**CITY OF MACEDONIA  
BOARD OF ZONING AND BUILDING CODE APPEALS  
MEETING AGENDA  
March 16, 2022**

**To:** Zoning Board of Appeals  
**From:** Chris Hall  
**Subject:** Variance Requests for Don Basch Jewelers, Fairlane Drive  
For Consideration by the Board on April 20, 2022  
**Cc:** Mayor Molnar, Bob Rodic, Rachael Gambatese  
**Date:** February 18, 2022

**DON BASCH JEWELERS  
FAIRLANE DRIVE  
MACEDONIA, OHIO**

**SUBJECT:** Don Basch Jewelry (new building) – Site Plan Review

**A-300**

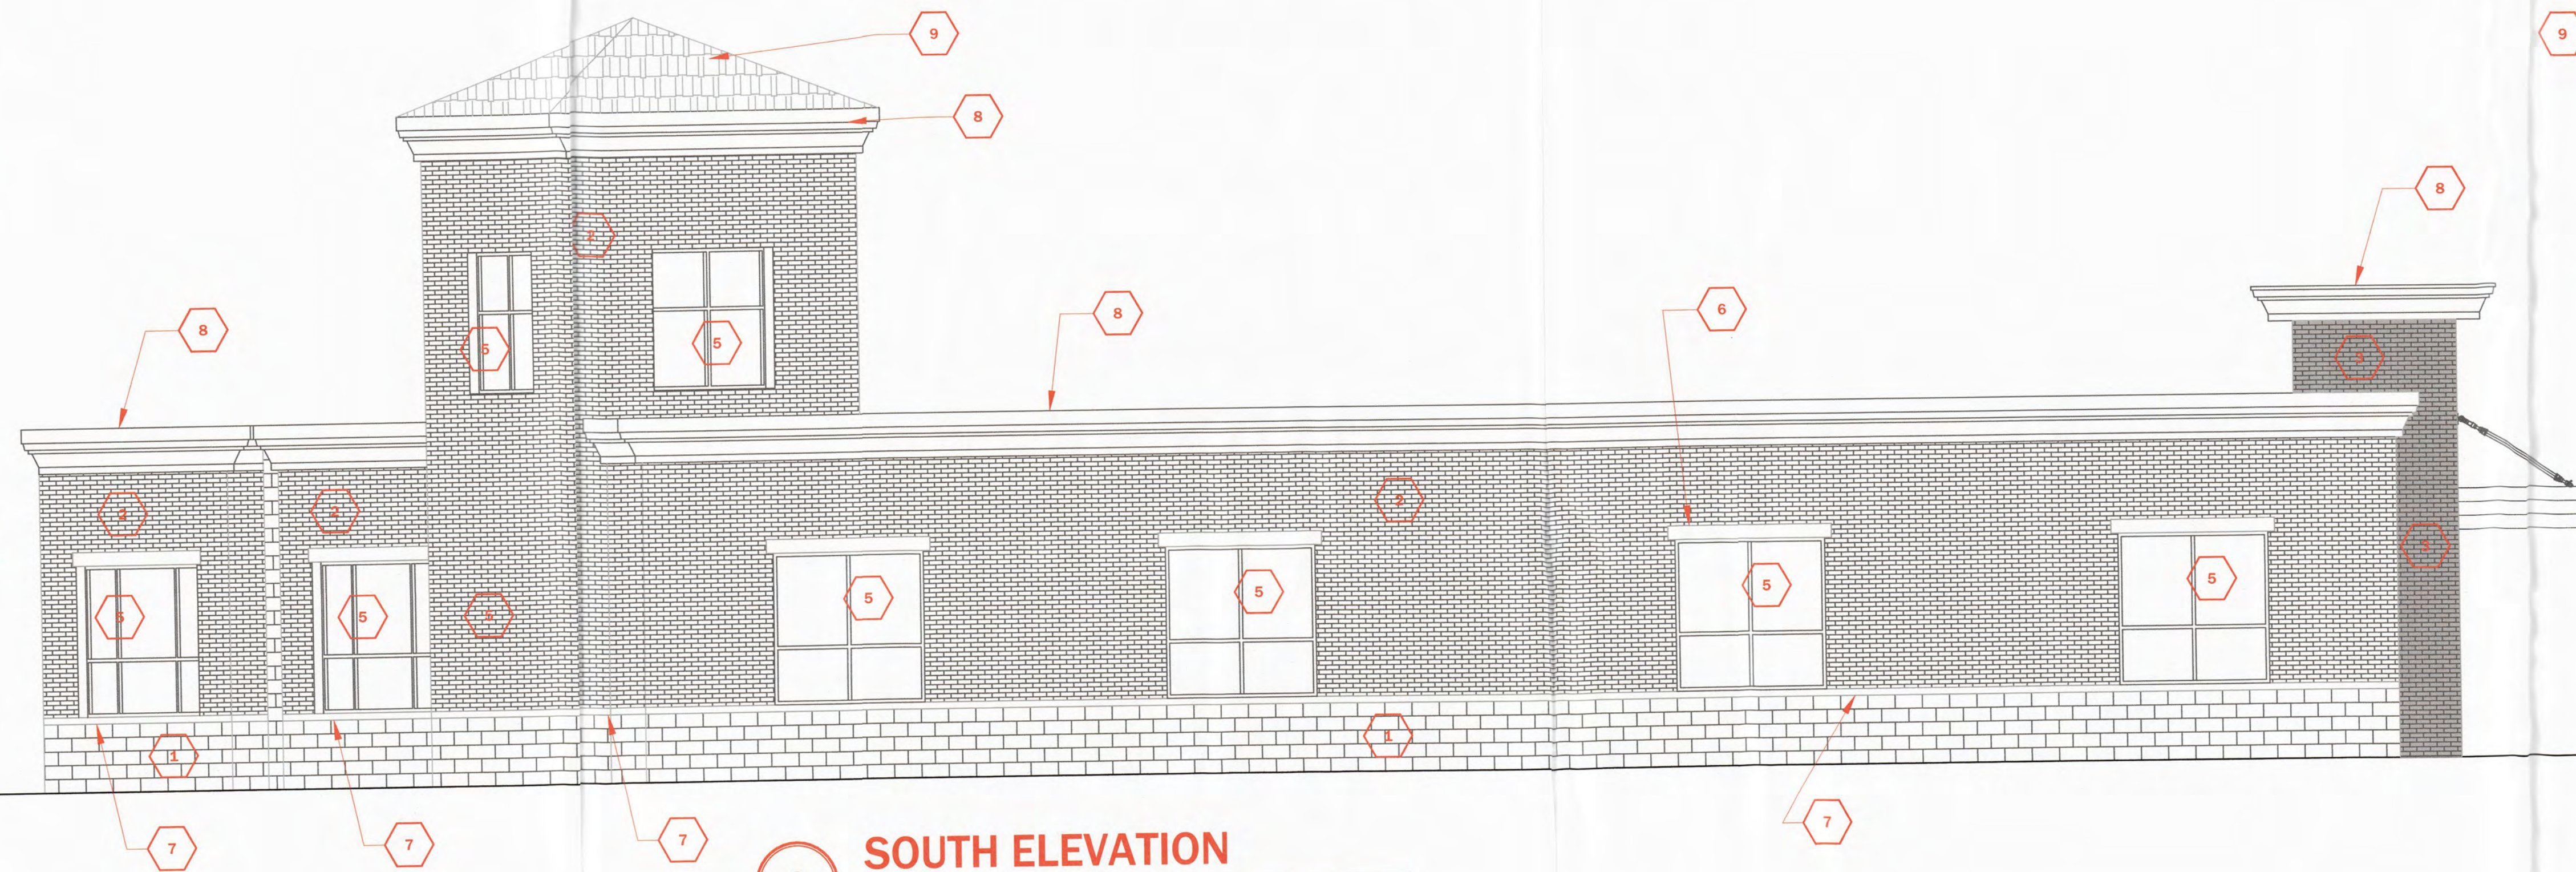
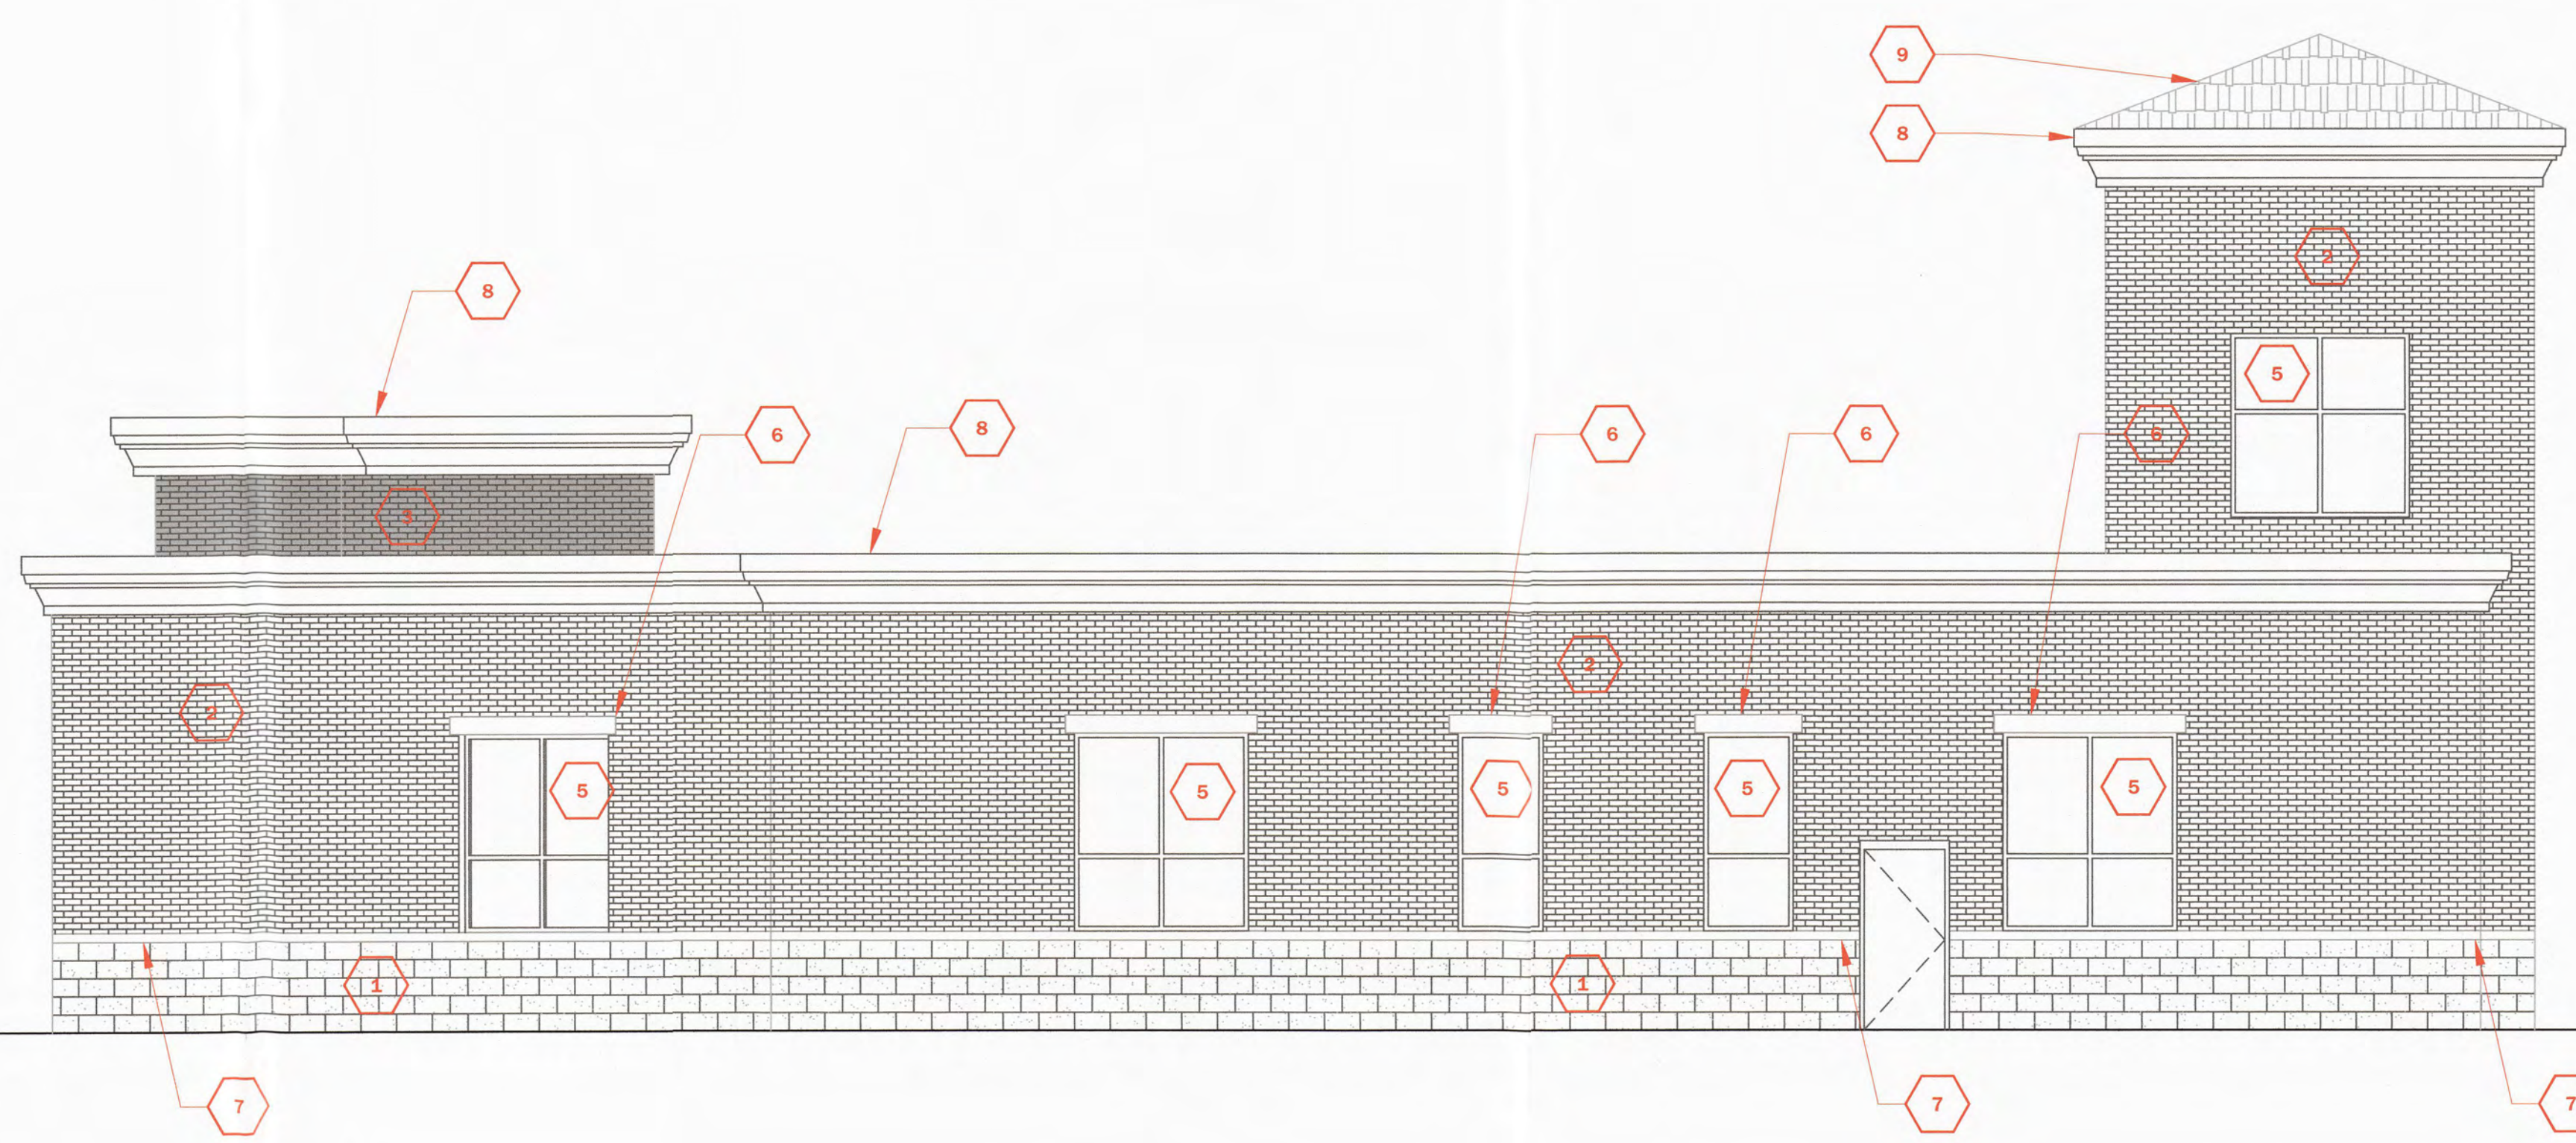
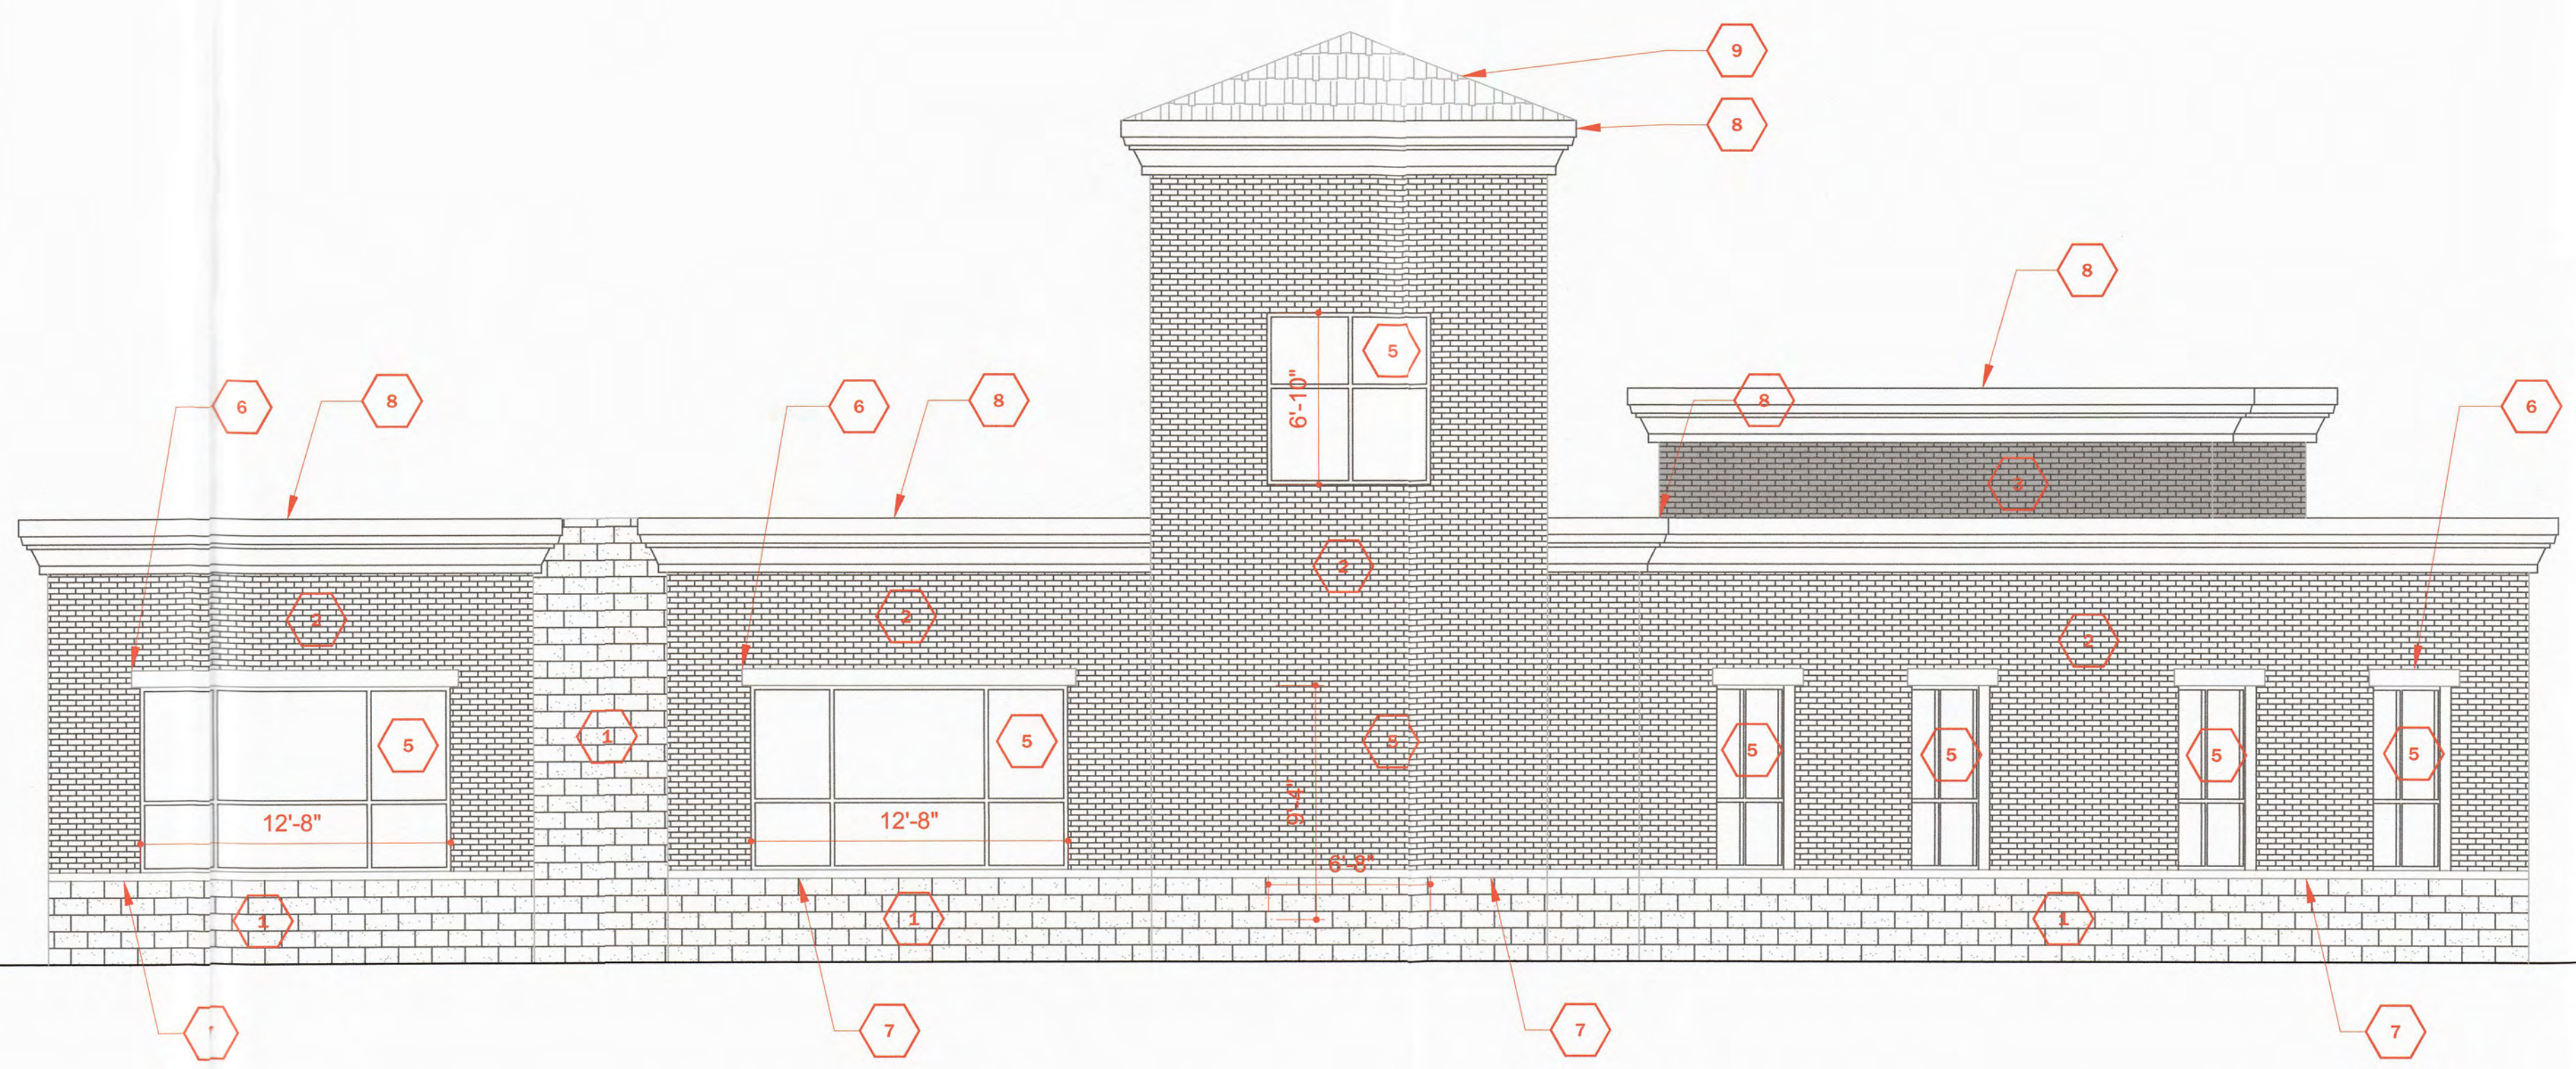
- 2) Section 1167.06 (g) provides a maximum building height of three stories or 40 feet. **ACTION ITEM: The height of the building is now shown as 42 feet to the roof peak of the tower. The Building Official should confirm if the proposed building height adheres to the definition of building height pursuant to Section 1133.02 of the Code. Regardless, I am concerned about the height of the tower when compared to the rest of the building (see number nine below).**

- 9) Architectural elevations are now submitted with this application. In general, the building design is acceptable and will compliment the corner frontage on Route 8 and 82. However, a few concerns are noted and should be discussed with the City Designer. **ACTION ITEM: 1) the windows must include muntin bars; 2) there is too much EIFS at the tower roof peak. This is a prominent feature and the materials should compliment the highly visible location at Route 8 and 82. Moreover, the height of the tower is excessive when compared to the remainder of the building (~17') and should be reduced; 3) the use of concrete block is not acceptable in the Town Center District; and 4) the roof should be standing-seam metal and not asphalt shingle similar to other recently approved buildings.**
